# UNITED STATES PATENT AND TRADEMARK OFFICE

APPLICATION NO.	FILING DATE	FIRST NAMED INVENTOR	ATTORNEY DOCKET NO.	CONFIRMATION NO.
10/803,198	03/18/2004	Olivier M. Parriaux	ICB0166	4841
24203	7590	02/02/2007	EXAMINER	
GRIFFIN & SZIPL, PC SUITE PH-1 2300 NINTH STREET, SOUTH ARLINGTON, VA 22204			TURNER, SAMUEL A	
			ART UNIT	PAPER NUMBER
			2877

## Office Action Summary

## DETAILED ACTION

FIG. 5A

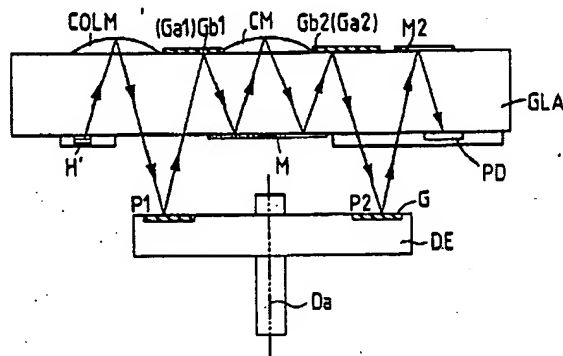
With regard to claim 35 and 36, Ishizuka teaches a device utilizing light diffraction for measuring translation, rotation or velocity(Fig. 5A), the device comprising:

a light source emitting an incident light beam(Fig. 5A, H');

at least one light detector for detecting a resultant interference beam(Fig. 5A, PD);

a diffraction grating assembly located on a light path of the incident light beam between the light source and the at least one light detector(Fig. 5A; G, GLA),

the diffraction grating assembly comprising a first reflective grating assembly(Fig. 5A, G) and a second reflective grating assembly(Fig. 5A, GLA);

wherein the first grating assembly is mobile along a given displacement relative to the second grating assembly(Fig. 5A, G);

wherein the first and second grating assemblies are arranged to diffract at least a portion of the incident light beam(Fig. 5A);

the incident light beam reaching the first grating assembly where the incident light beam is partially diffracted along two different directions thereby forming two partial light beams(Fig. 5A, P1) which reach the second grating assembly(Fig. 5A, GLA), and, thereafter, the first grating assembly(Fig. 5A, P2),

thereby forming, after diffraction by the first grating assembly, the resultant interference beam resulting from interference of the two partial light beams along an output direction(Fig. 5A, P2; the combined beam incident on PD);

wherein the second grating assembly, the source, and the at least one detector form an integrated measuring head(Fig. 5A, GLA) and

the first grating assembly further comprises a first reflective grating that defines a scale for the device(Fig. 5A, G) and

wherein the light source and detector are integrated on a semiconductor substrate bearing the second grating assembly(Fig. 5A; H',PD).

Ishizuka fails to teach wherein the light source and detector are integrated in a semiconductor substrate bearing the second grating assembly.
